## RESEARCH, ANALYSIS AND EXPERTISE IN ENERGY POLICY

March 14, 2011

Ms. Lesley Griffiths  
Mr. Herbert Clarke  
Co-Chairs  
Lower Churchill Joint Review Panel  
160 Elgin Street, Ottawa ON  
K1A 0H3

Unit costs for Muskrat Falls power

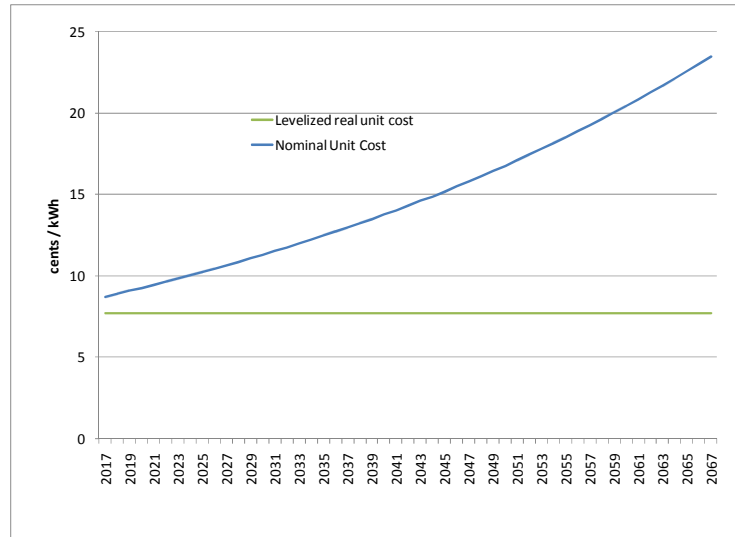
Statements 2 and 3 mean that, were the Proponent to receive 7.7 cents for every kWh produced, in the year when it is produced without adjustment for inflation, the resulting revenues would be sufficient to repay the total construction costs (including financing costs during construction). As the real value of 7.7 cents will decline year to year, due to inflation, the constant-dollar value of this revenue stream would also decline over time, as shown in the following graph.

Thus, the statement that the levelized cost of 7.7 cents/kWh is a nominal levelized cost is inconsistent with the Proponent’s treatment of the cost data. This treatment rather suggests that the LUEC provided is a **real** levelized cost.

To the best of my knowledge — and assuming, based on the foregoing, that the cost figures provided are stated in real (constant) dollars — the Proponent has not yet provided a straight-forward estimate of the current-dollar (nominal) unit cost of the project, either in actual or in levelized (average) terms. As noted above, nominal unit costs are the only indicator of actual rate impacts.

However, based on the prices per MWh indicated in U-27, it seems that the average nominal cost of the project – the average value of the blue Nominal Unit Cost line in the above graph — is over \$149/MWh.
